ADDENDUM #1

**PROJECT: JAMES RIVER POWER STATION UPGRADE 2023-12-14
CITY UTILITIES OF SPRINGFIELD, MO**

DATE: 01/24/24

ME2

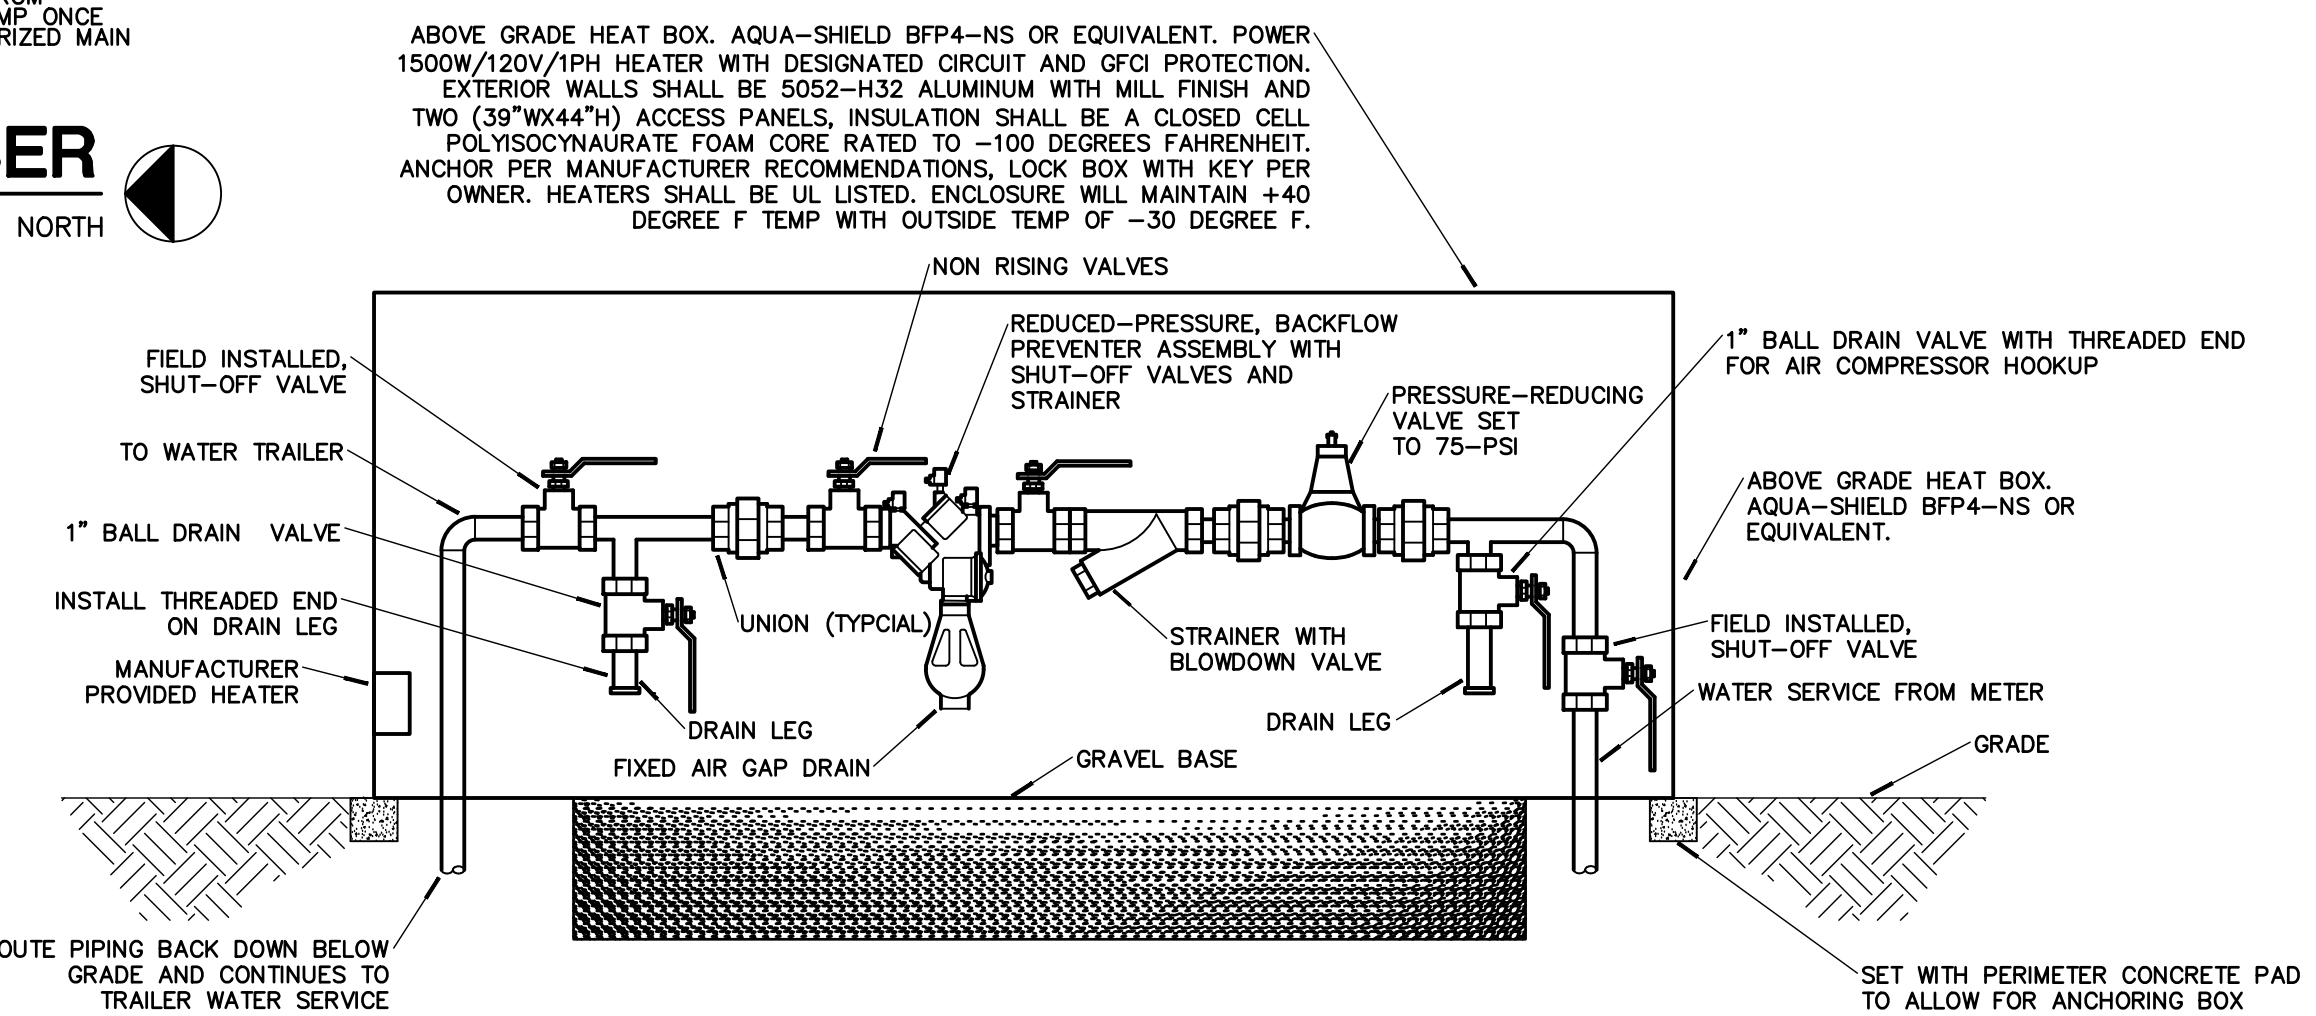
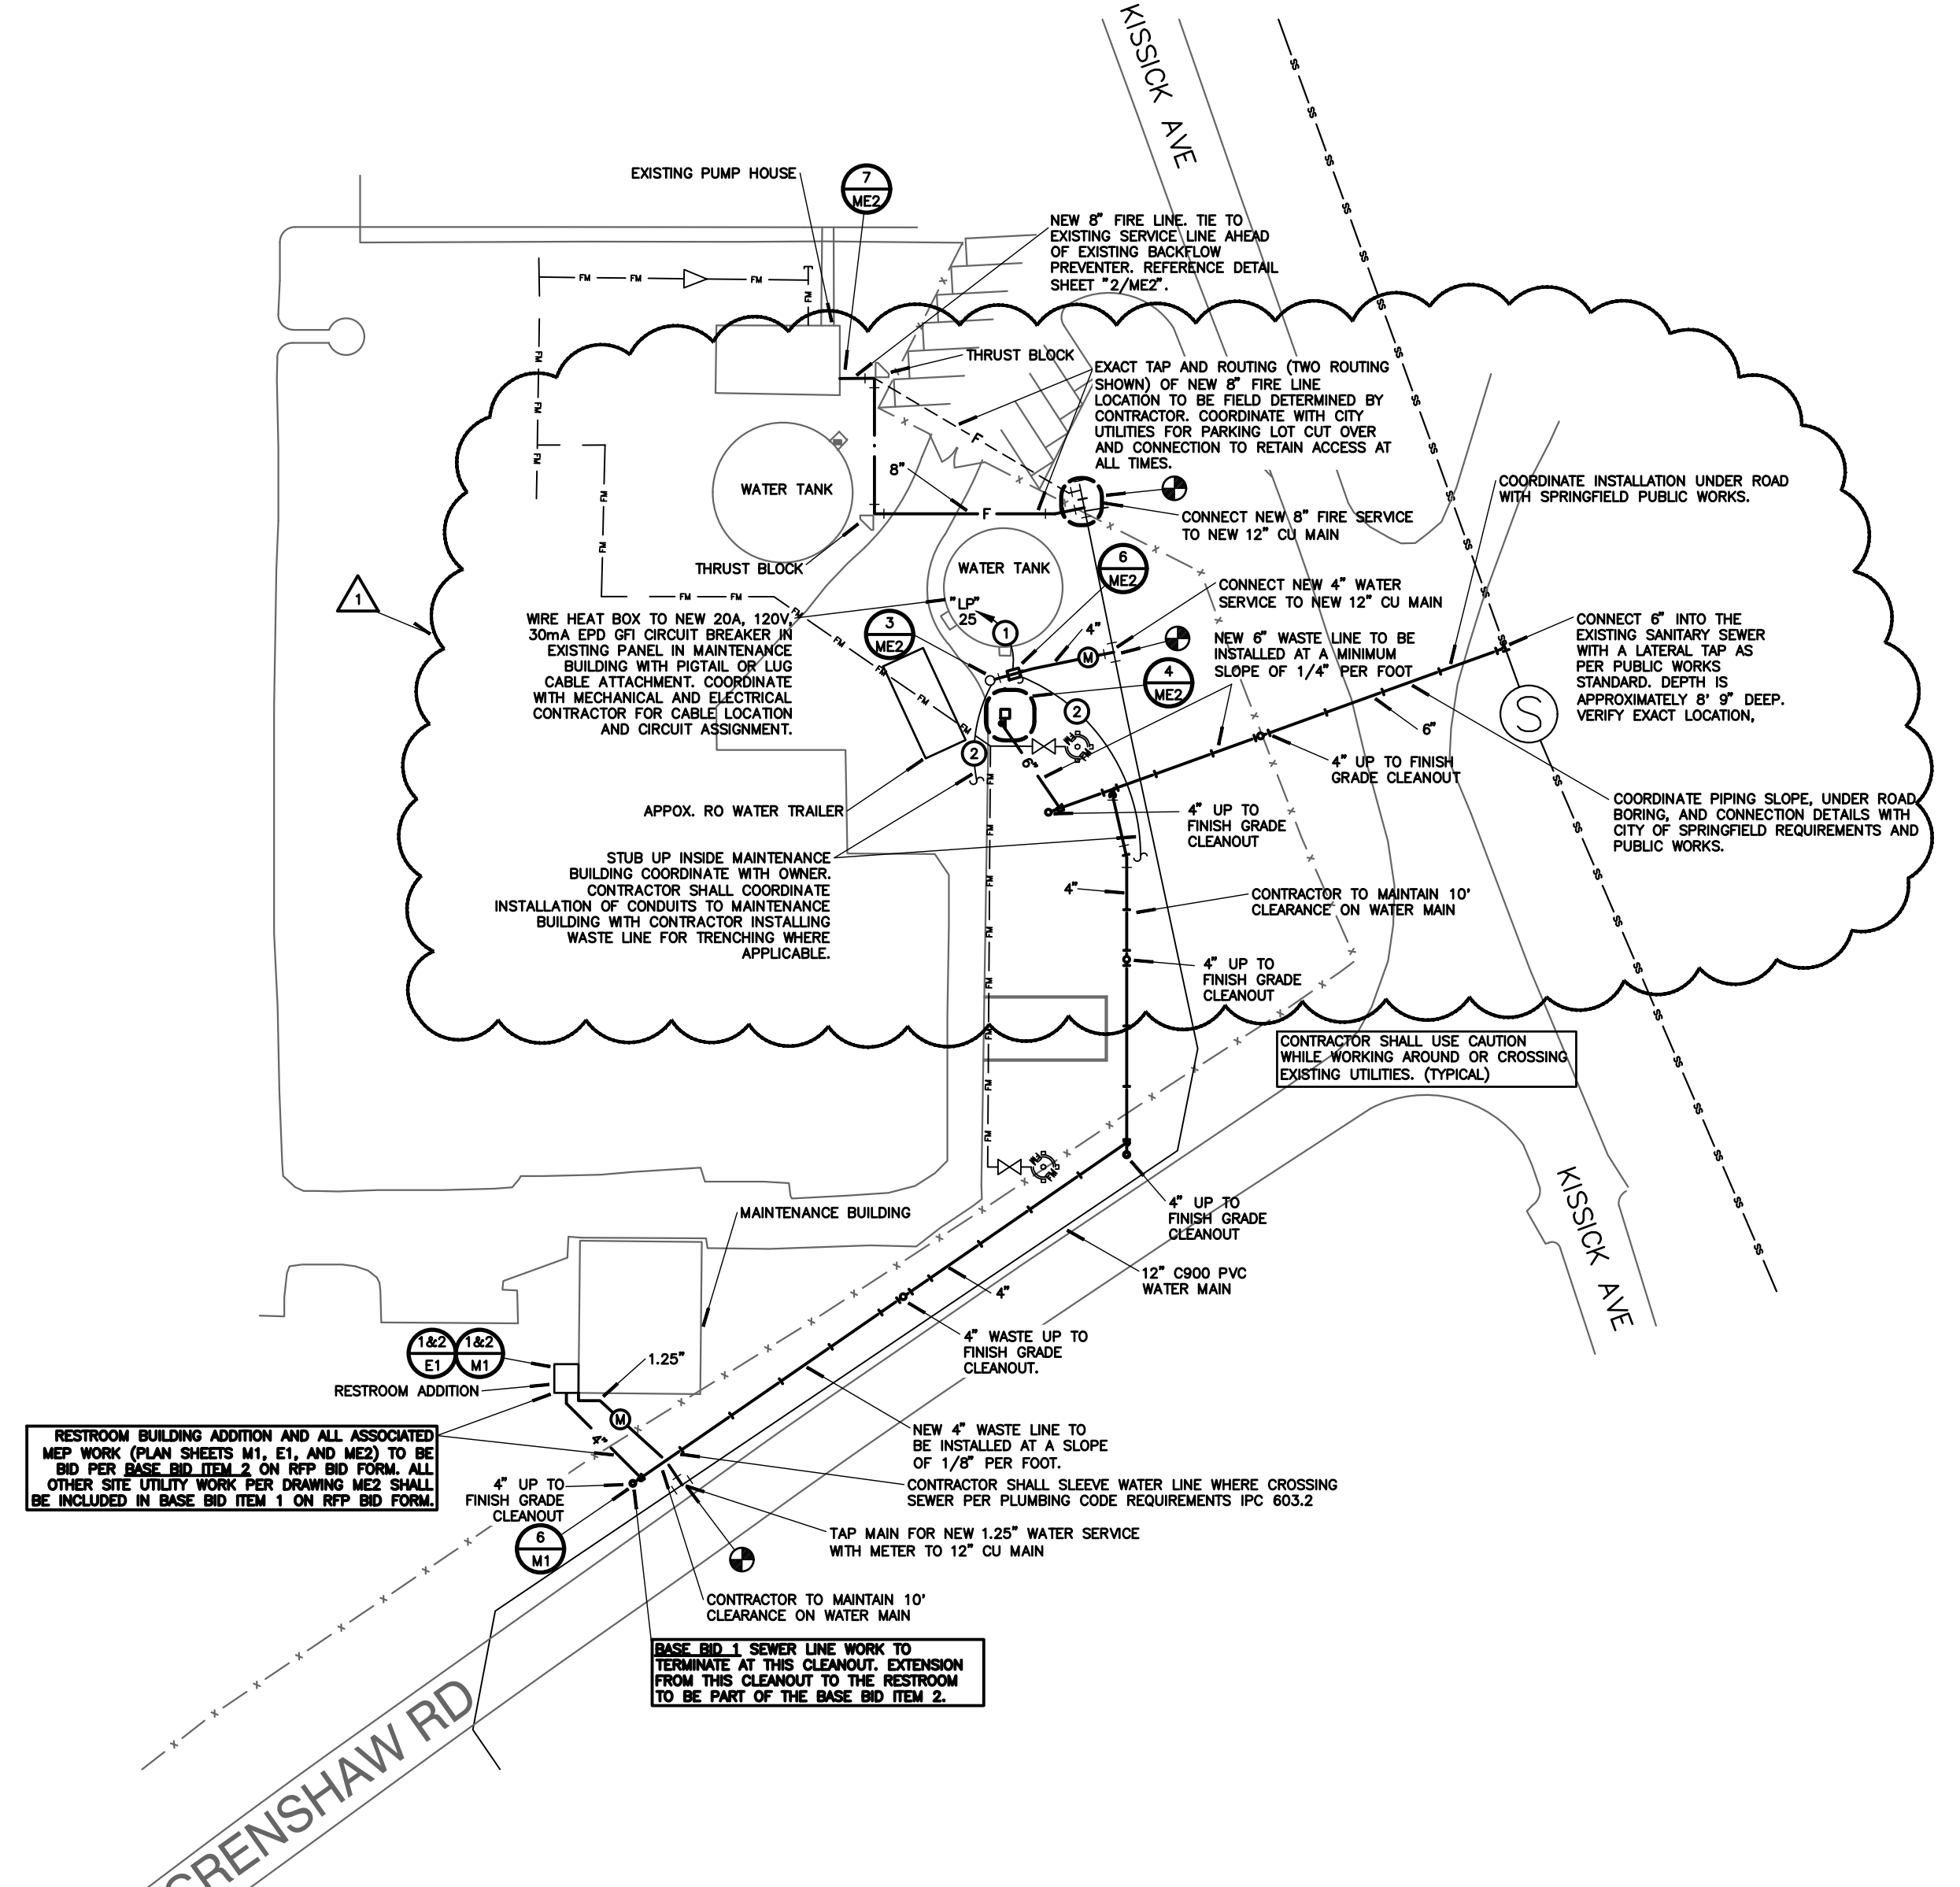
Reference Sheet ME2”

1. The discharge manhole detail was revised for battery powered meter along with discharge and construction details added. The meter model was revised to battery powered unit. Provide meter specified or approved equal.
2. The waste line out of the gravity fed manhole was changed to 6” and main pipe revised to be 6” with cleanouts and end manhole omitted.
3. Above grade heat box power was revised to be powered from Maintenance building.
